# **Japan's Research of the Lap Strap Angle of CRS, and Revised Proposal to the “ECE/TRANS/WP.29/GRSP/2016/14”**

60th GRSP Informal Group on Child Restraint System

13<sup>th</sup> September 2016

JASIC

# Measurement Condition

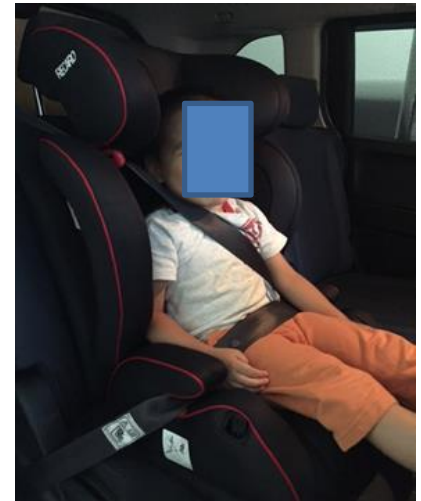
Lap strap angles of 22 types of booster seats/cushions currently available in Japan were researched.

Conditions of measurement:

- On a UN R44 test bench, a vehicle or a seat jig
- With a P3 dummy, other 3-year-old dummy or a 3-year-old child
- At the front edge of the belt

# Results

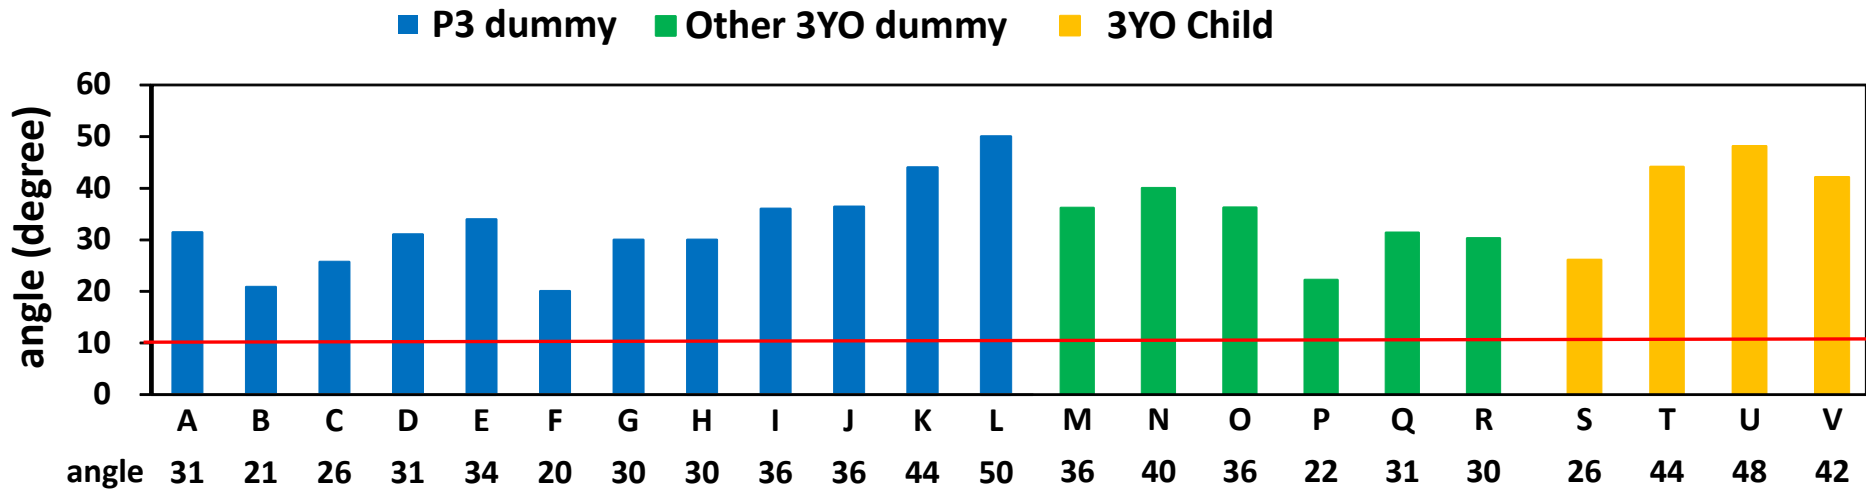
- The angle was measured on both the left and right sides; the smaller of the two is indicated.
- The smallest angle was 20°.
- In this research, all booster seats/cushions meet the 10° criterion in the Netherlands' proposal.
